ORIGINATION FORM

Proposed Revisions to a Standard Plans Index (Please provide all information — Incomplete forms will be returned)

Index Number: 715-003
Sheet Number (s): All (1-3)
Index Title: Utility Conflict Pole

New Standard Plans Index for a different light pole type.

LAST REVISION 11/01/21	REVISION	DESCRIPTION:	 FY 2022-23 STANDARD PLANS	UTILITY CONFLICT POLE	INDEX 715-003	SHEET 1 of 3
---------------------------	----------	--------------	---	-----------------------	------------------	-----------------

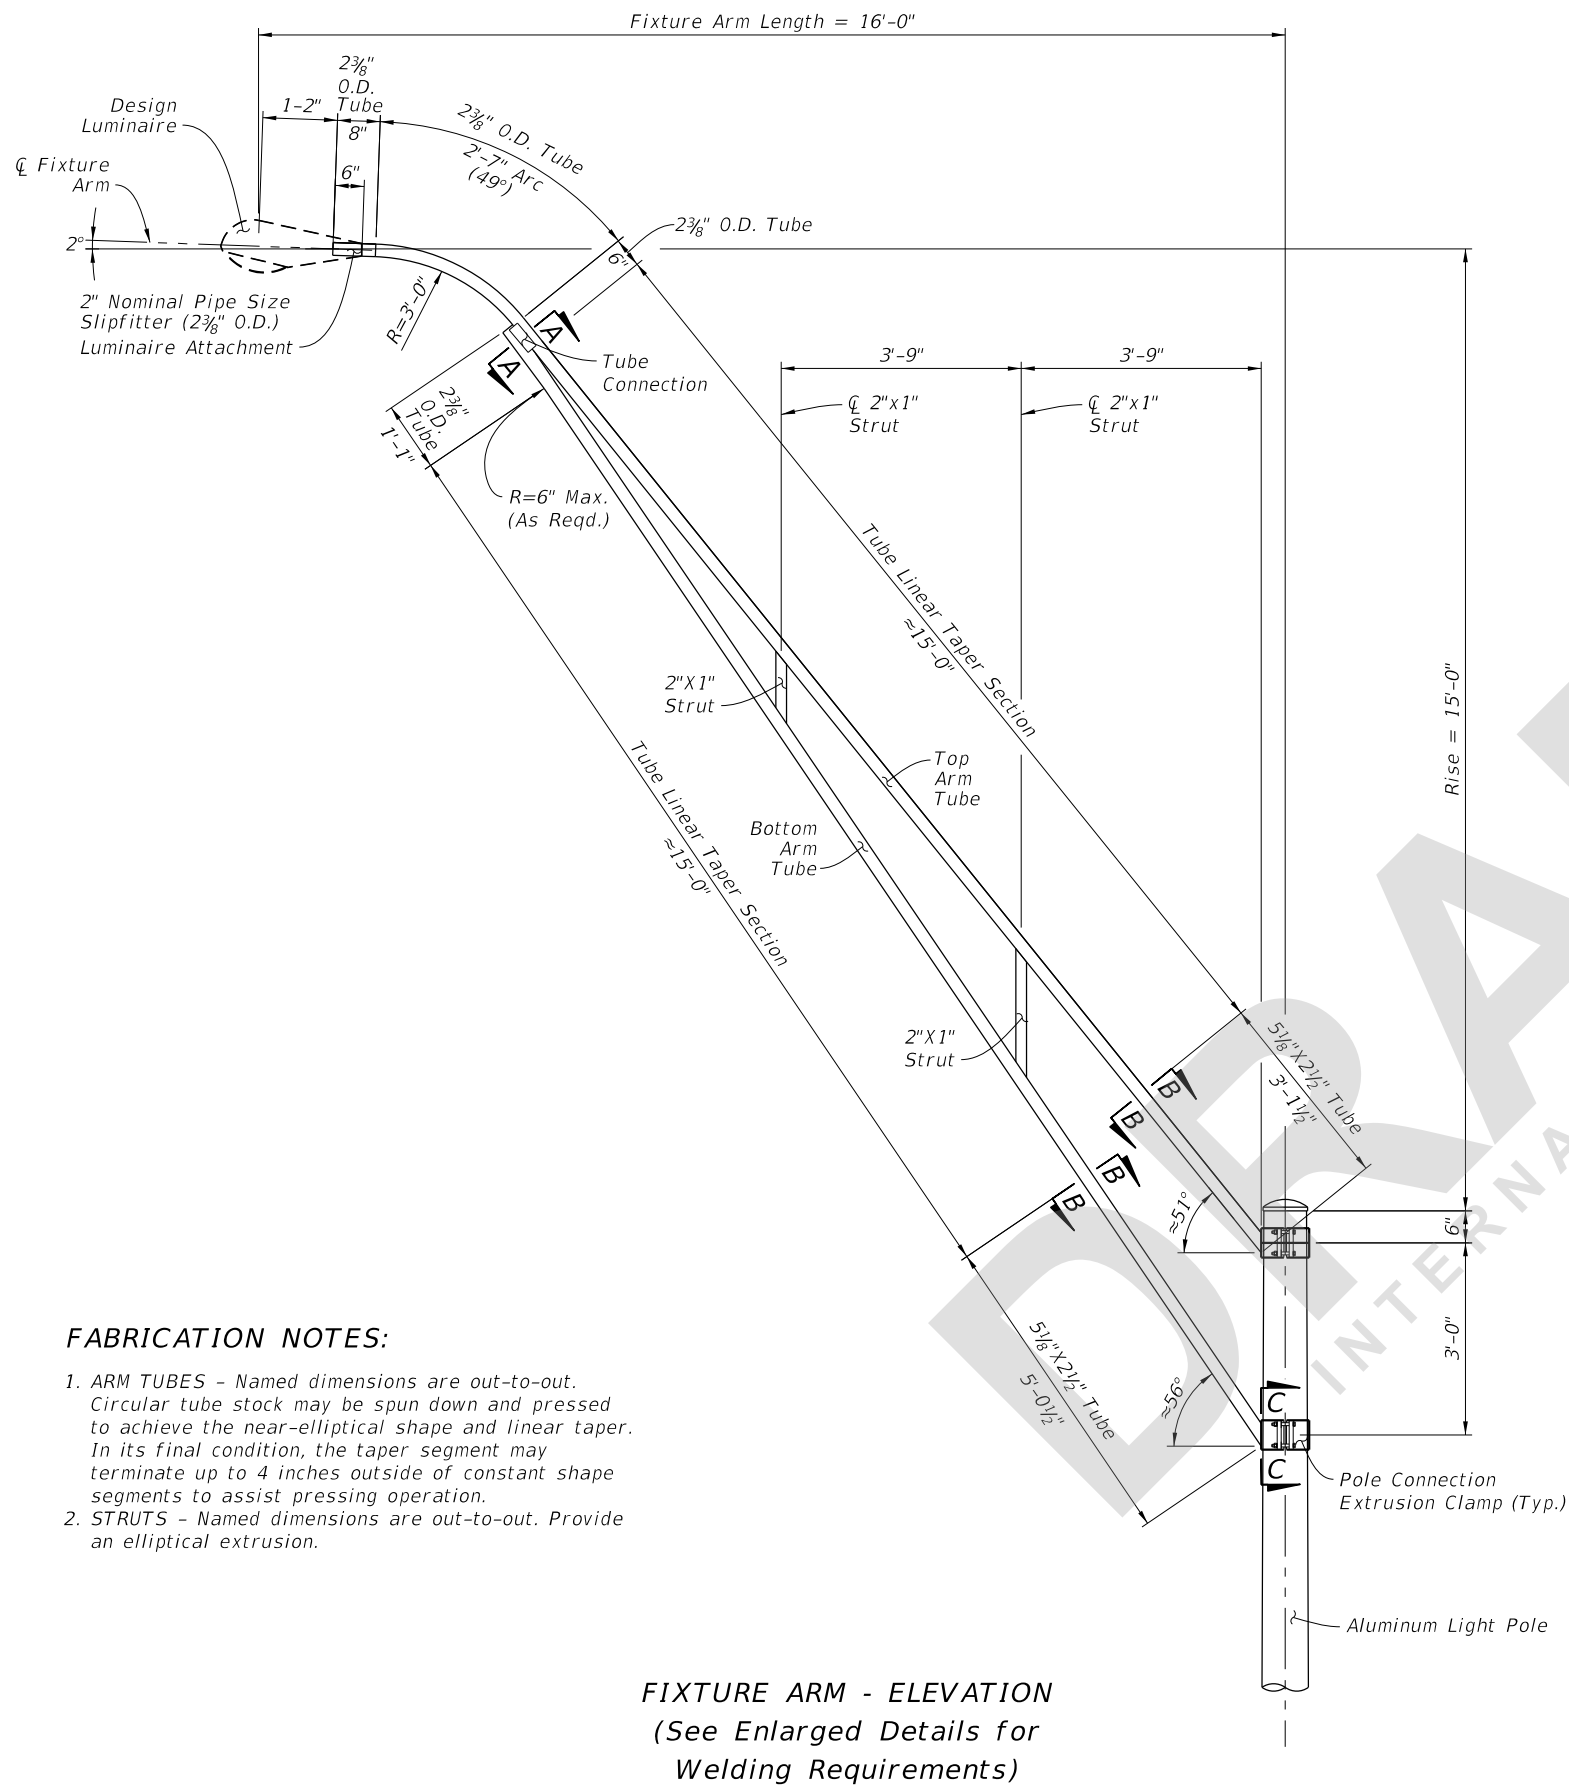
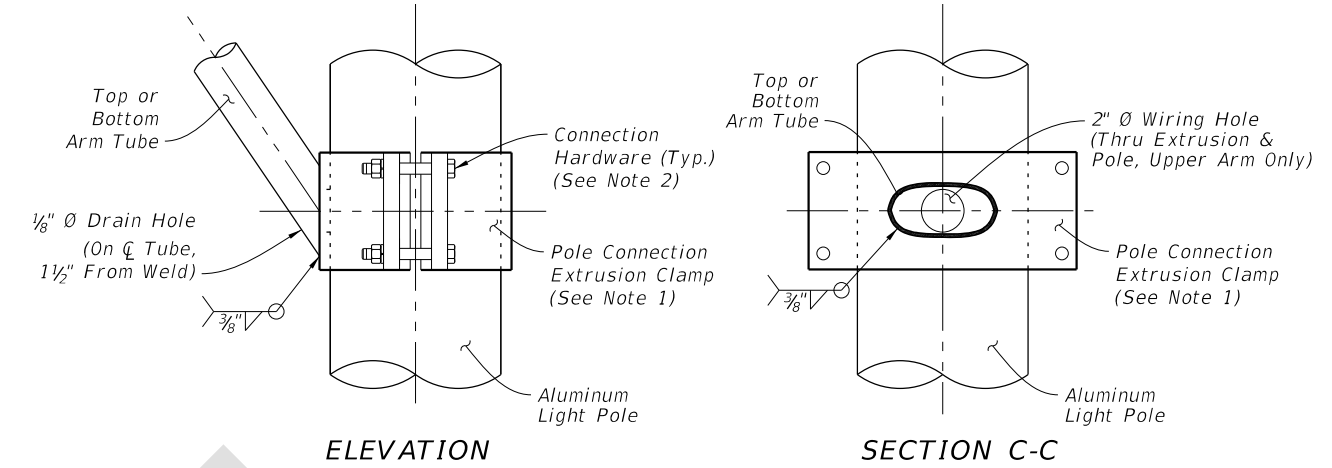
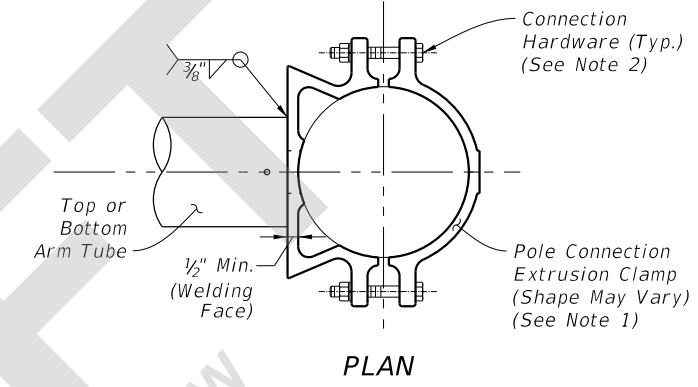
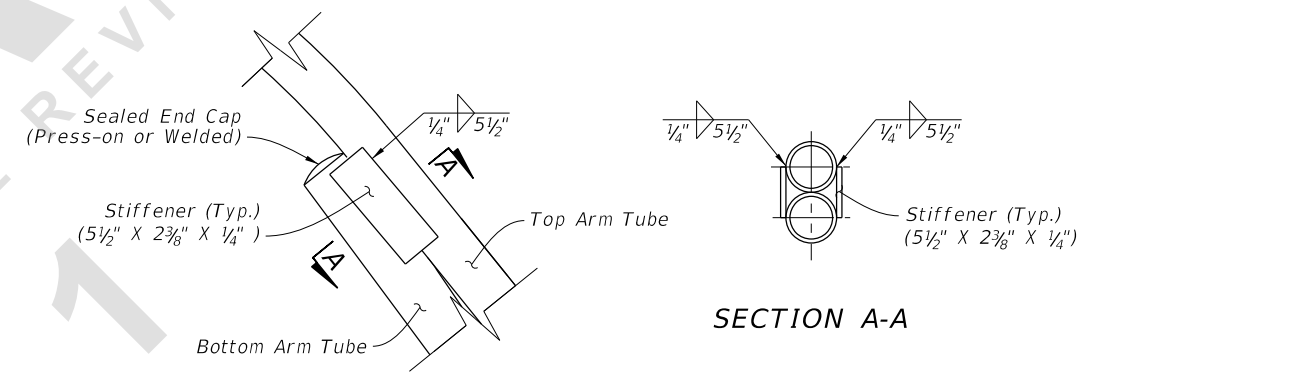
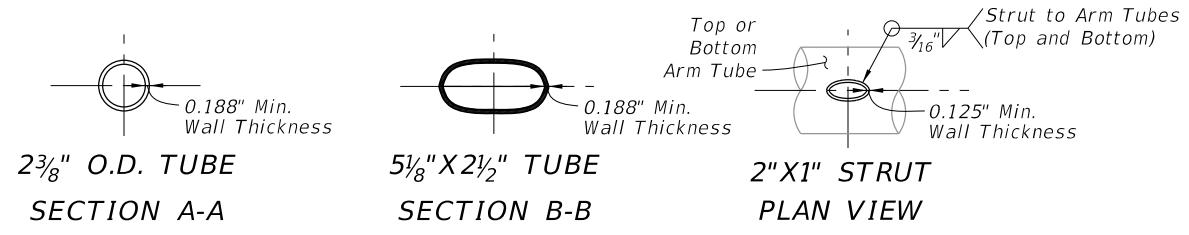
This new pole type has fixture arm dimensions of 16-foot horizontal by 15-foot rise to assist designers with avoiding overhead power lines and other utilities when conventional poles won't fit these project constraints.

In recent years, the Utility Conflict Pole concept has been widely requested through the use of project-specific Pay Items. This new Index provides a standardized design that will largely remove the need for project-specific Pay Items, structural designs, and CO plans reviews.
